**NORTH PENRITH DEFENCE SITE SUBDIVISION OF STAGE 3A (SSD 5348)
NOTICE OF EXHIBITION**

ATTACHMENT 1

TRANSPORT FOR NSW TRANSPORT CLUSTER COMMENTS

NORTH PENRITH DEFENCE SITE SUBDIVISION OF STATE 3A (SSD 5348)

FUTURE ROAD BUS MANOEUVRABILITY

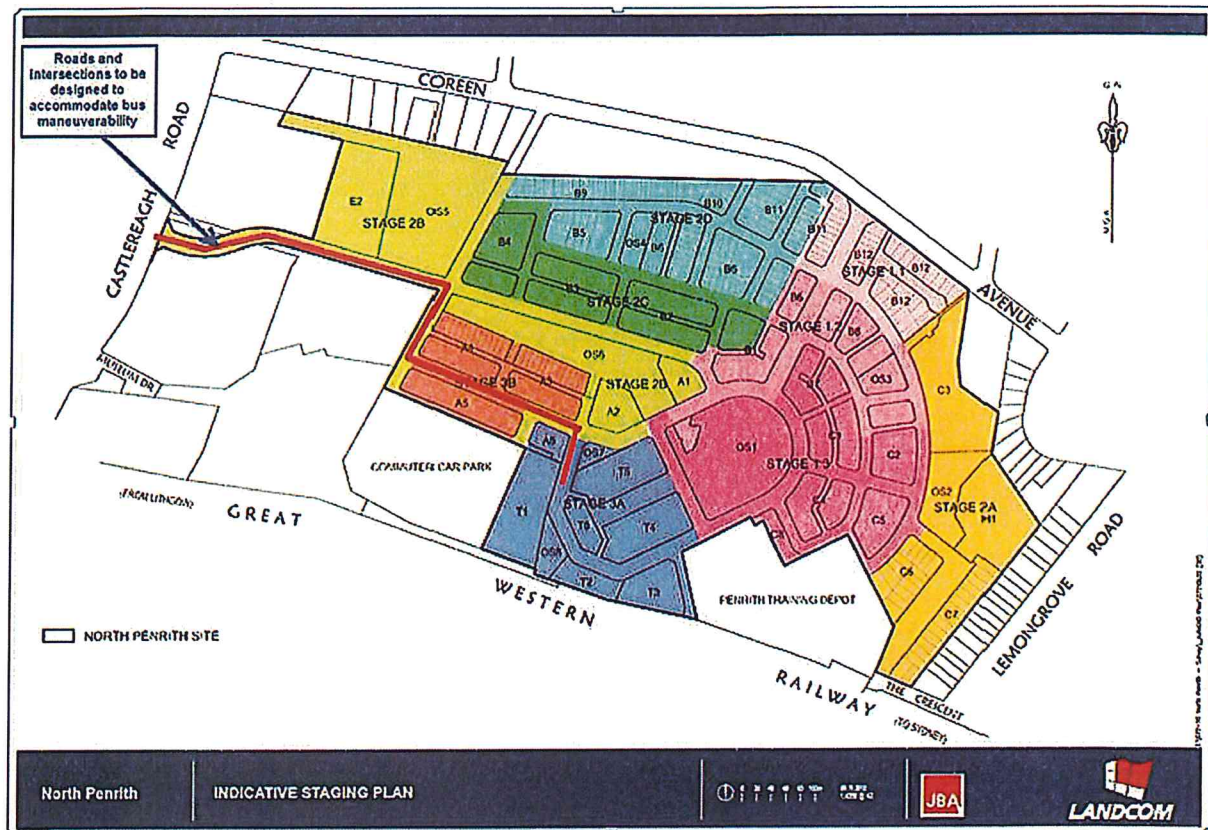
The diagram illustrated in **Attachment 2** was provided to the developer at this stage, and indicated the roads and intersections that should be considered. These particular roads at least should be designed to accommodate overall bus manoeuvrability, bidirectional movement and swept paths of buses up to 14.5 metres in length such that there is no centreline crossing.

TfNSW continues to require these amendments.
